UNITED STATES PATENT AND TRADEMARK OFFICE

APPLICATION NO.	FILING DATE	FIRST NAMED INVENTOR	ATTORNEY DOCKET NO.	CONFIRMATION NO.
10/600,262	06/20/2003	Thomas W. Lanni	P 302109	7547
7590	03/31/2005		EXAMINER [REDACTED]	VU, BAO Q
Eric S. Chen PILLSBURY WINTHROP LLP Suite 2800 725 South Figueroa Los Angeles, CA 90017			ART UNIT [REDACTED]	PAPER NUMBER 2838
DATE MAILED: 03/31/2005

Office Action Summary	Application No.	Applicant(s)
	10/600,262	LANNI, THOMAS W.
	Examiner Bao Q. Vu	Art Unit 2838

DETAILED ACTION

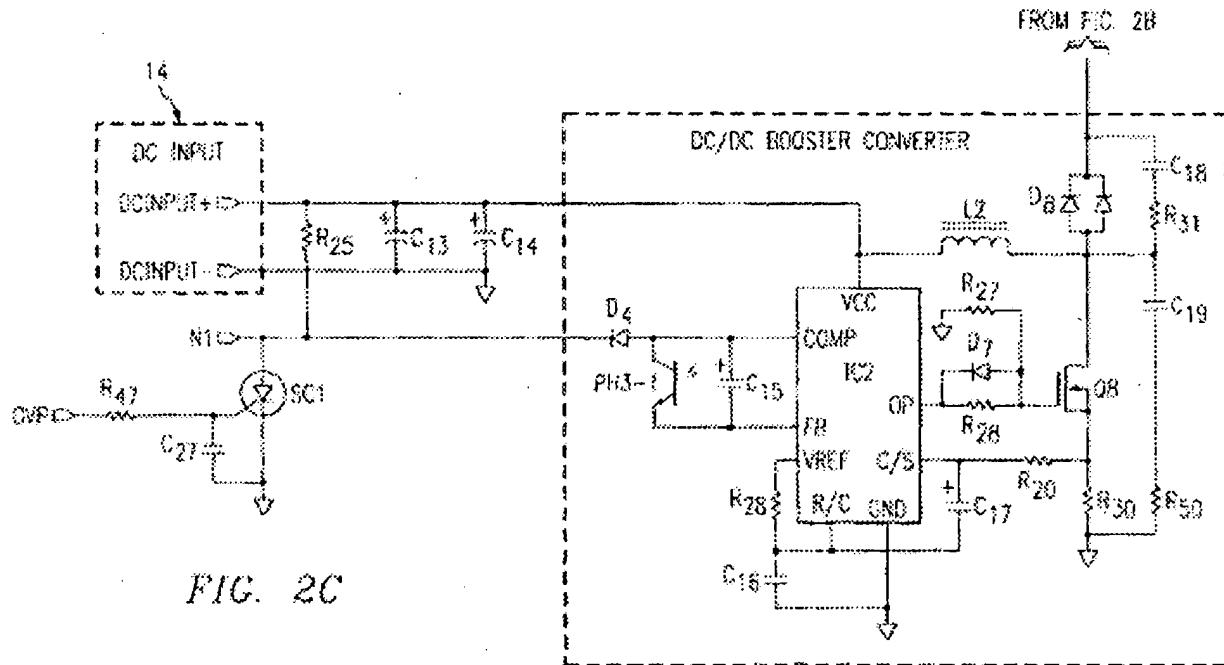
5. Applicant's arguments filed 1-11-05 have been fully considered but they are not persuasive. One of ordinary skill in the art would know from looking at the figures 2c and 2b that inductors L2 and L3 are the secondary windings of transformer T1, the double bars on top the inductors means that they are connected to the transformer T1, and have a common core (meaning of the doubled lines in the drawings). If the inductors were not connected as suggested by applicant (similar to L1- an independent

inductor without any connection to a common core), they would not have the double bars on top. Therefore, the inductors L2 and L3 are secondary of transformer T1.

Also, looking at figure 2C above, the control circuit controls the switch Q8, and boost type inductor (L2)-diode (D8) –switch (Q8) configuration [similar to applicant's boost configuration (figure 3) of a inductor (203)-diode (212) –switch (208)], this switch Q8 is being controlled by the controller to create a boosted voltage and only difference is that the transformer is not a centered tapped and that is where the teachings of Riggio come into play- the obviousness rejection.
